# Value Engineering - Site Plan:

MSBA SCHEMATIC DESIGN SUBMISSION

MARCH DD BASELINE ESTIMATE

JUNE DD ESTIMATE

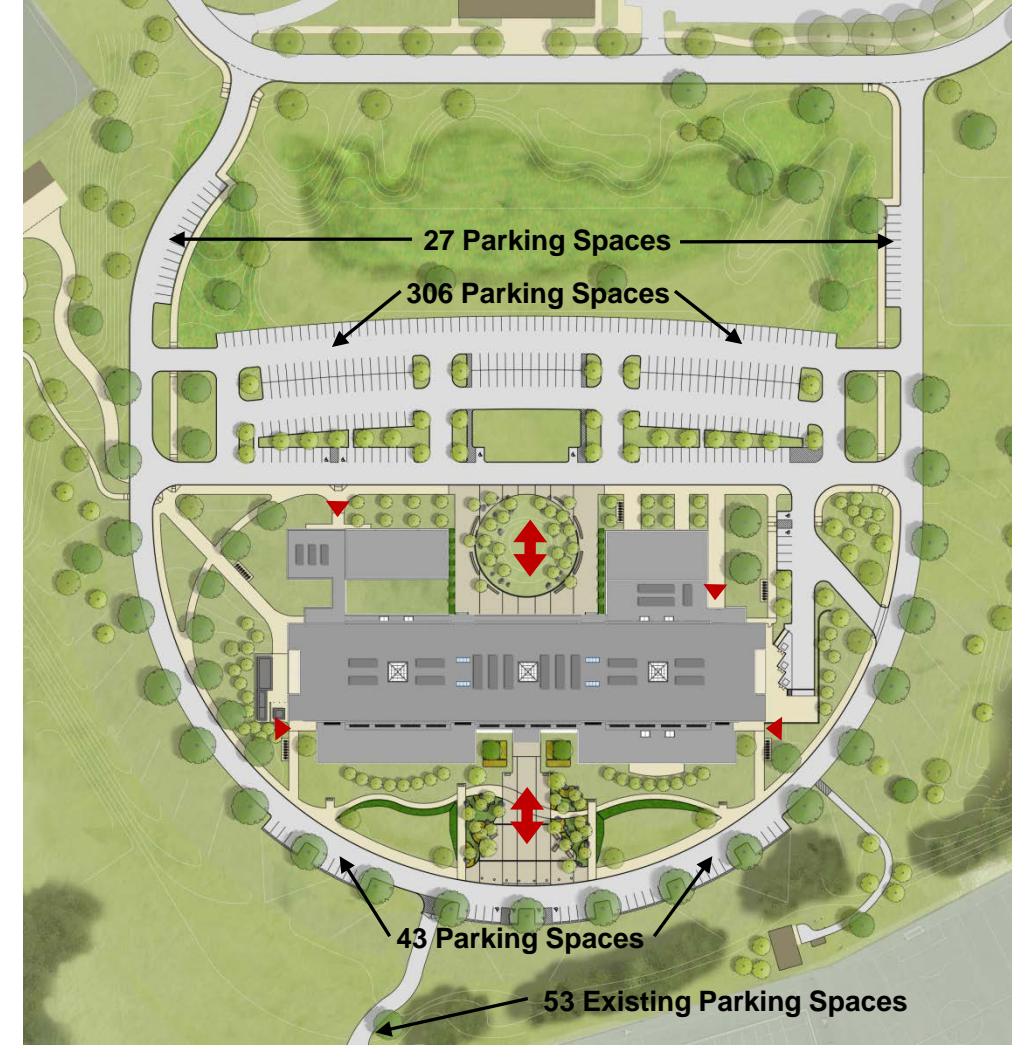
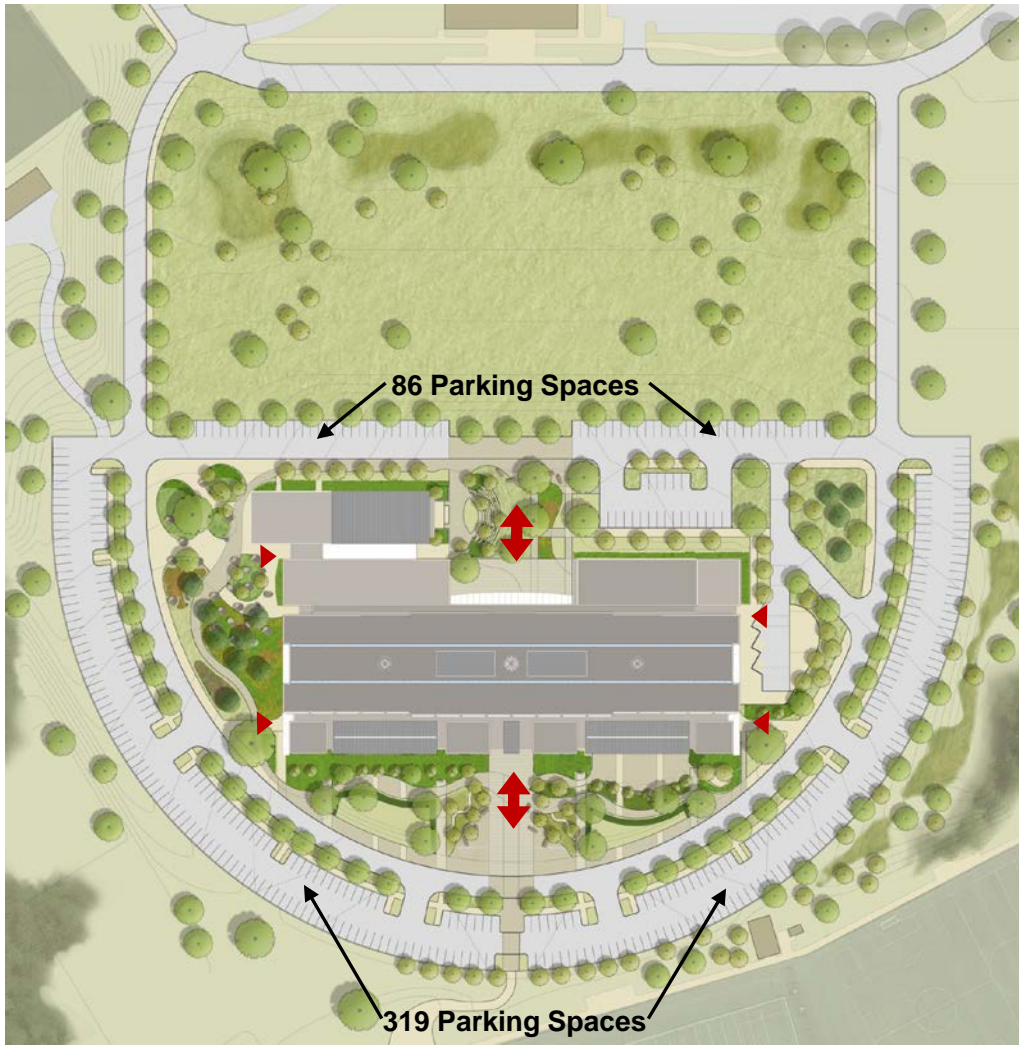
The site has less paving, more undisturbed green space and a greener water retention system. Utilities to the site have been reduced.

- Utilities:**
- 4416' new looped water line (SD-VE target to use existing)
  - 1730' of new high pressure gas line
  - 35 new catch basins
  - 2778' of new sewer main piping
  - 6 new water quality structures (SD-VE target for SWM Bio savings)

- Utilities:**
- 1600' of new water line loop
  - 2350' of new high pressure gas line
  - 50 new catch basins
  - 1462' of new sewer main piping
  - 3 new water quality structures

- Utilities:**
- Re-use existing water line loop
  - 1430' of new high pressure gas line
  - 15 new catch basins
  - 1300' of new sewer main piping
  - No water quality structures (utilize bio-retention areas)

- Landscape/Site Improvements: \$1.8m**
- Delete outdoor amphitheater
  - 376 new parking spaces and re-use 53 existing spaces

- Achieved VE Savings from SD Targeted List:**
- Reduction in site hardscape, bollards, and pavement
  - Reduction in planting
  - Delete irrigation system and add sleeves
  - Reduced cut/fill and grading
  - No water storage collection system

MSBA SCHEMATIC DESIGN SUBMISSION

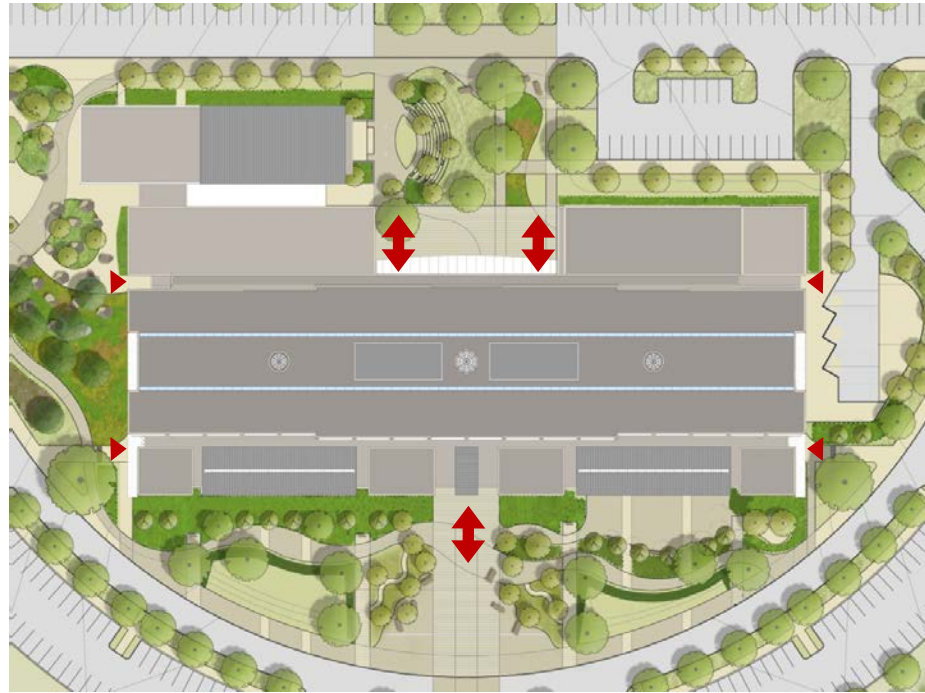
- Skylights at stairs
- 2 roof penthouses (boiler and chiller)
- No roof screens

- Targeted roof savings (materials, details and delete curved roofs)
- Targeted savings to reduce design of 3 cupolas at light wells
- 1/3 reduction in continuous skylights at light shafts

MARCH DD BASELINE ESTIMATE

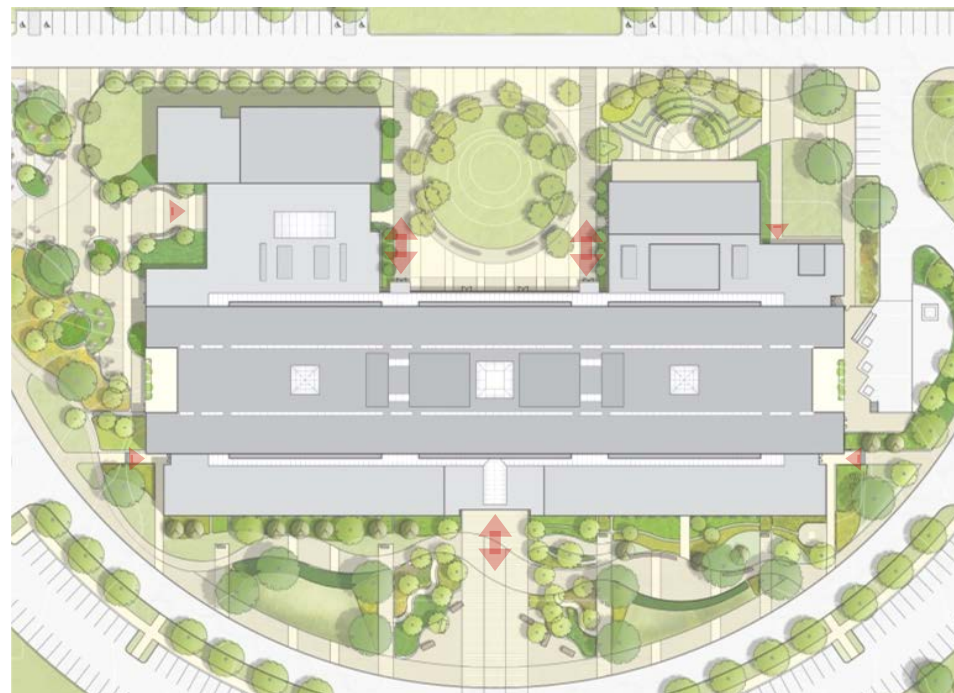
- 8 skylights at stairs
- 2 roof top penthouses (boiler and chiller)
- Mechanical roof screens

- TPO roofing and no curved roofs
- 3 skylights at light wells
- 1/3 reduction in continuous skylights at light shafts

JUNE DD ESTIMATE

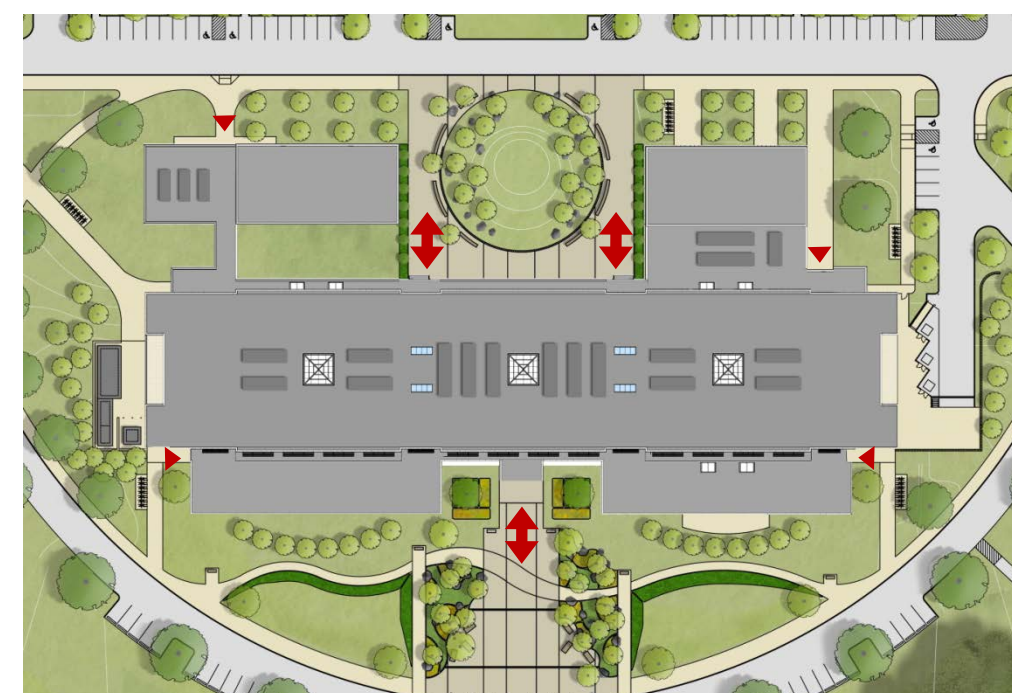
- 6 skylights at stairs
- 1 roof penetration (boiler)
- No roof screens

- PVC roofing and no curved roofs
- 3 skylights at light wells
- Eliminate continuous skylights and light shafts but retain daylighting to classrooms from corridor side via light wells (Energy model improved)
